INSTRUCTION TO SERVICE

ITS: 6786

SECTION:	219 Engine and Transmission
WRITTEN BY:	Mike Pearson
SUBJECT:	Replace electric motor mounting bolts

Figure 1: Electric Motor Support Bracket Upper Bolt Locations

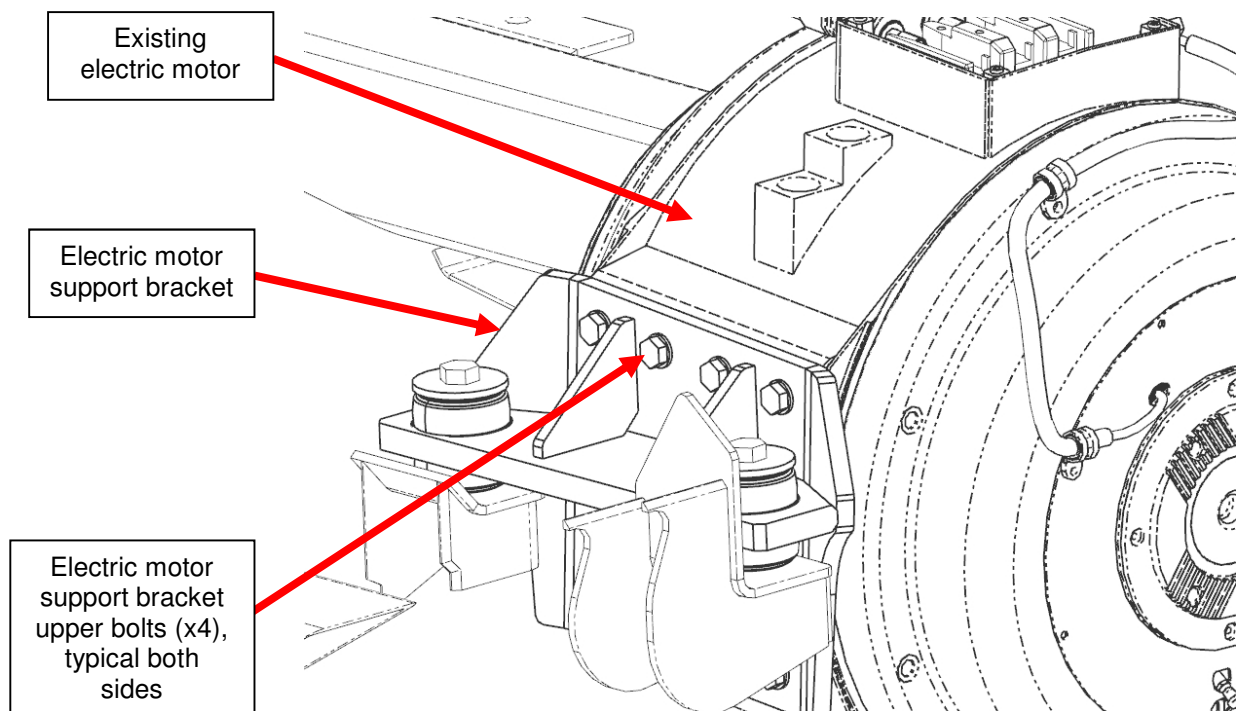
**NOTE:** Each top mount bolt and washer (4 on each side) are to be removed, new bolt and washer installed and torqued one at a time before the next bolt is to be started.

3. Remove and discard one of the existing upper electric motor support bracket bolts with its associated washer. Apply a few drops of Loctite p/n 081034 to the bolt threads of new bolt p/n 727577 and reinstall the bolt with new washer p/n 20W08000 in the same threaded hole, torque bolt to 54 ± 5 ft*lbs.
4. Repeat Step 3 on the remaining top electric motor support bracket bolts (x7).

Figure 2: Electric Motor Support Bracket Lower Bolt Locations

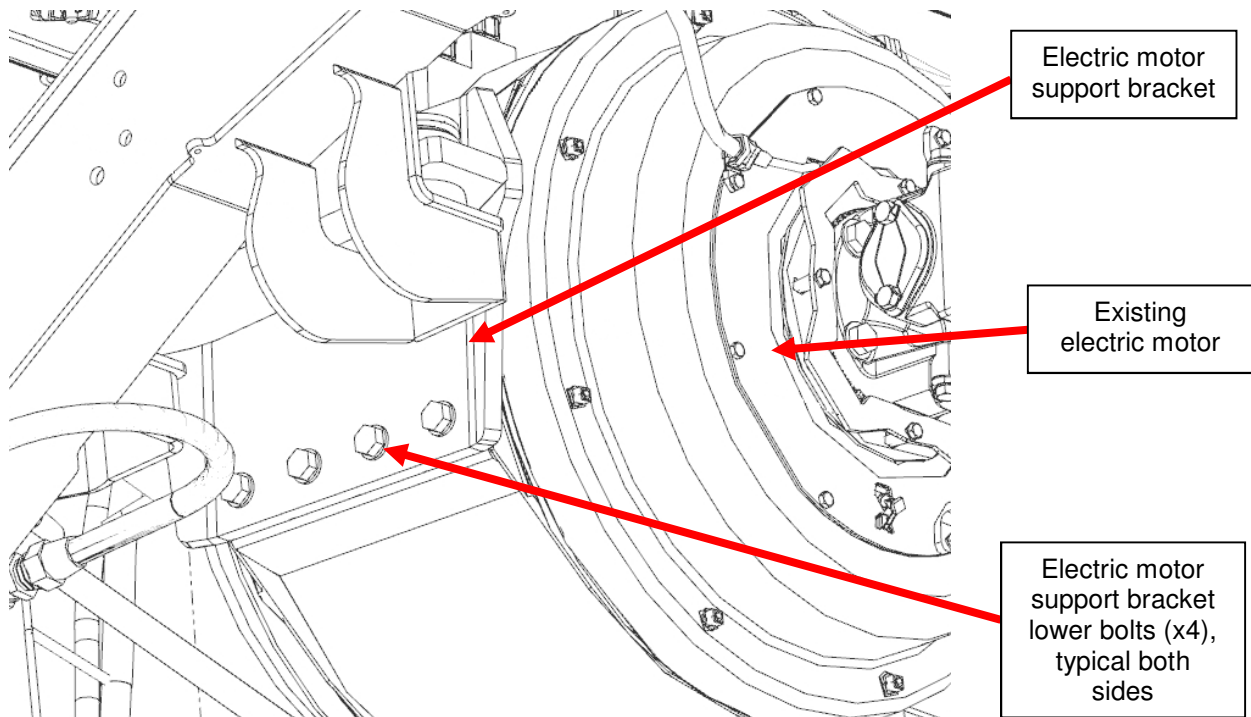
**NOTE:** Each top mount bolt and washer (4 on each side) are to be removed, new bolt and washer installed and torqued one at a time before the next bolt is to be started.

7. Remove and discard one of the existing lower electric motor support bracket bolts with its associated washer. Apply a few drops of Loctite p/n 081034 to the bolt threads of new bolt p/n 727577 and reinstall the bolt with new washer p/n 20W08000 in the same threaded hole, torque bolts to 54 ± 5 ft*lbs.
8. Repeat Step 7 on the remaining top electric motor support bracket bolts (x7).
